Recall Bulletin 10420FRV

RECALL BULLETIN:
10420FRV

PRODUCT(S) AFFECTED:
Bounder Classic,
Encounter

SUBJECT:
Install new Manufacturer Federal Certification Tag

Figure 1

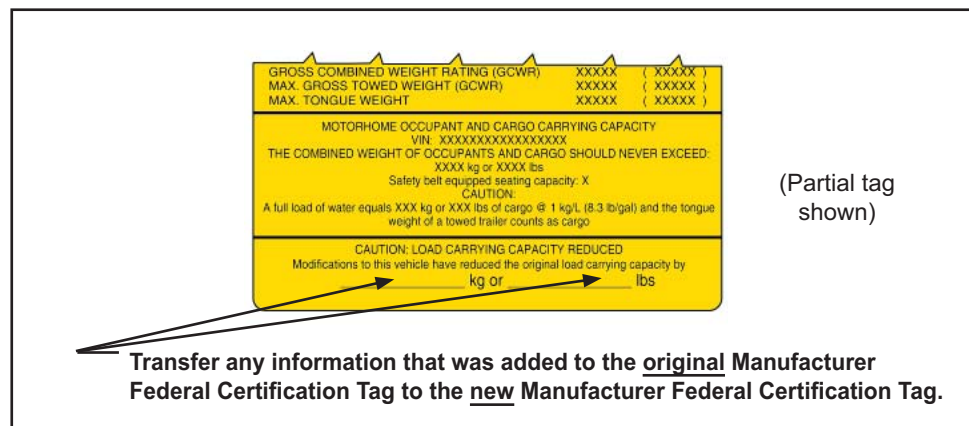
1. Locate the original Federal Certification Tag, adhered to the wall behind the driver's seat.
2. Record any additional weight information (if present) that was written on the original Manufacturer Federal Certification Tag due to the addition of options after the motor home was manufactured. (See Figure 1.) Transfer this information to the new Manufacturer Federal Certification Tag using a black, fine point, permanent marker.

3. a) If the original Federal Certification Tag is loose or peeling, remove it and discard. Remove any adhesive residue in the application area using a clean shop cloth slightly dampened with isopropyl alcohol.
b) If the original Federal Certification Tag is adhered securely in place, use a black permanent marker to deface it.
4. Peel and tear approximately 1" from the top of the adhesive backing of the new Federal Certification Tag. (This will allow control of the application.) Slowly apply the new Tag directly over the original, using your fingers to smooth down newly-applied areas. (If the original Tag was removed in Step 3a, apply the new Tag in the same location as the original.) Continue to remove backing, working from top to bottom, until the entire tag completely adheres to and covers the original tag.
